RECORD PLANS-MATERIALS

RUTLAND TH 2610 BRIDGE  
 CONTRACTOR-BRIDGES INC. MONTPELIER,VT.  
 CONTRACT DATED- 12 MAY 1976  
 CONSTRUCTION BEGAN- 7 JUNE 1976  
 CONSTRUCTION COMPLETED- 24 AUGUST 1976  
 ACCEPTED- 31 AUGUST 1976  
 RES.ENGR.-HOWARD P. BARNES

BRIDGE PROJECT  
 TOWN OF RUTLAND  
 COUNTY OF RUTLAND

ROUTE No TH-1-CL-2 BRIDGE No B5

DECK PLAN SHOWING EXPANSION JOINT @ PIER  
SCALE 1/2" = 1'-0"

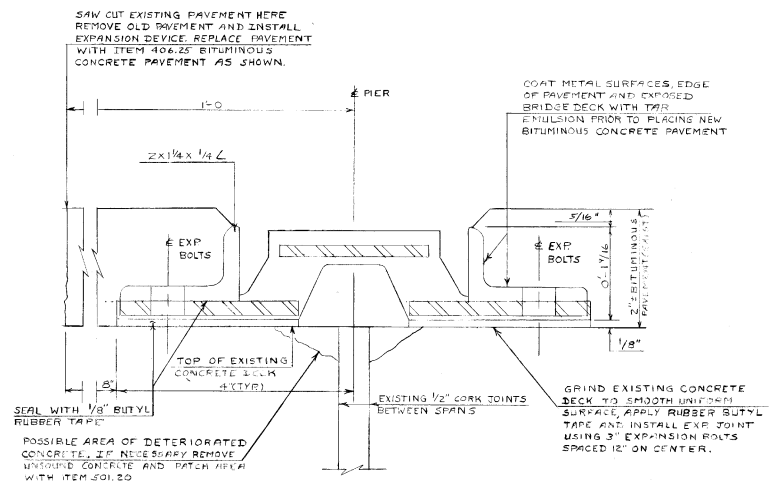
REVISIONS  
1. Revised Detail 'A' To Show New Styrofoam Joint In Curt Line And Bolt.  
2. Revised Section C-C Showing Bolts In Of Expansion Joint, End.  
3. Revised 'Deck Plan' Showing New Conc. And Bolt Cut Lines.  
D. Perkins & D. Willey  
June 76

REVISED EXPANSION JT. @ PIERS #1 & #2  
Scale 1/2"=1'-0"

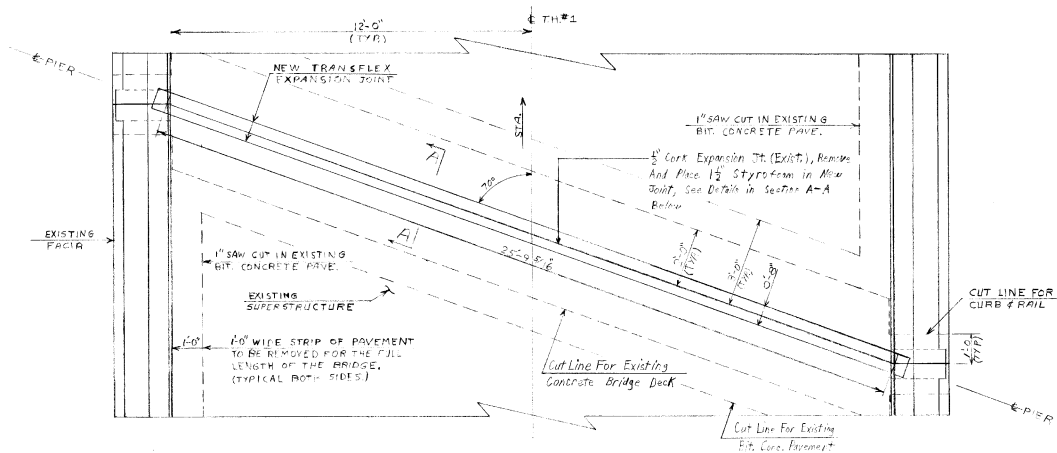
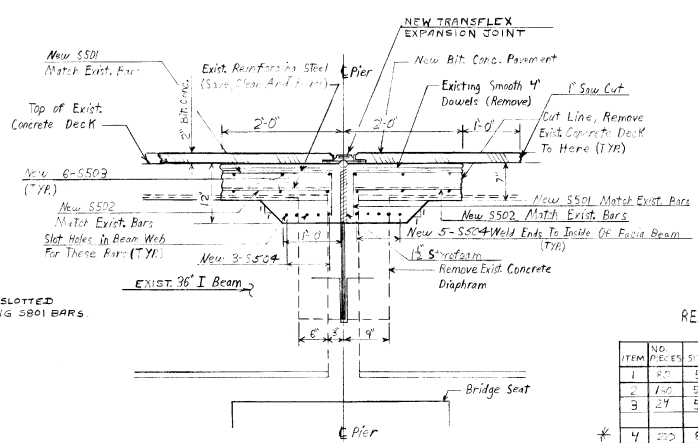
\* S504 BARS REPLACE 7-201'S AS PER W.M.S. 6-28-76 D.C.P.
